PCN – Process Change Notification

Change:	FW.91.TNC.M
Date:	2017/08/04
Author	Haley Tsai

Model#	Part Number	Changes
FW.91 Penta-band Cellular Flexible Whip Antenna TNC(M)	FW.91.TNC.M	<ol style="list-style-type: none"> 1. Amend $\varnothing 4 \pm 0.4\text{mm}$ to $3.7 \pm 0.2\text{mm}$. 2. Amend $\varnothing 61 \pm 0.3\text{mm}$ to $\varnothing 61 \pm 0.5\text{mm}$. 3. Amend $\varnothing 16.05 \pm 0.2\text{mm}$ to $\varnothing 16 \pm 0.5\text{mm}$. 4. Amend cap material from ABS to POM.

Illustration of Change

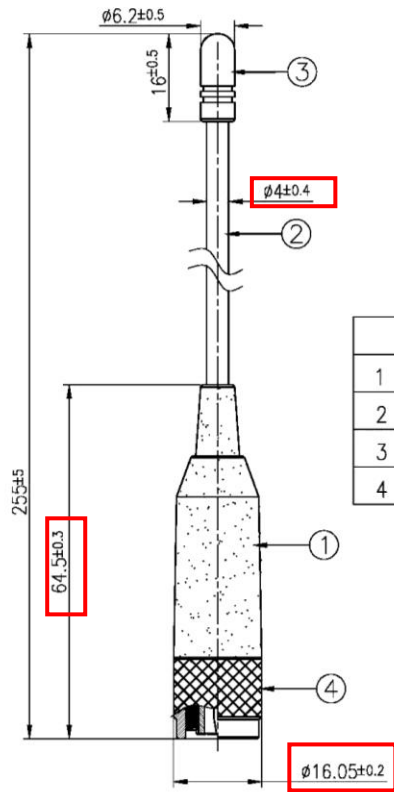
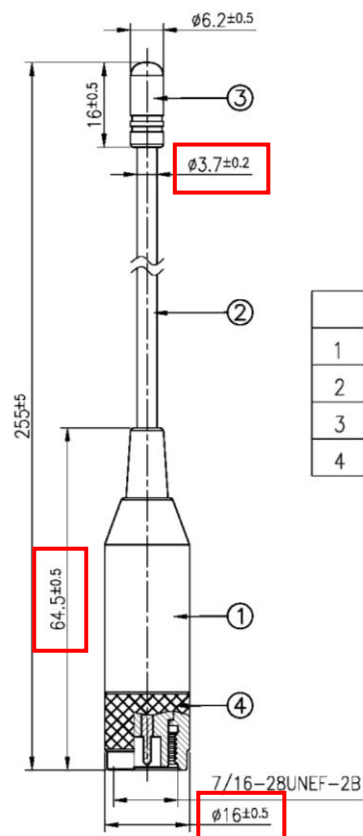
1. Amend $\varnothing 4 \pm 0.4\text{mm}$ to $3.7 \pm 0.2\text{mm}$.
2. Amend $\varnothing 61 \pm 0.3\text{mm}$ to $\varnothing 61 \pm 0.5\text{mm}$.
3. Amend $\varnothing 16.05 \pm 0.2\text{mm}$ to $\varnothing 16 \pm 0.5\text{mm}$.
4. Amend cap material from ABS to POM.
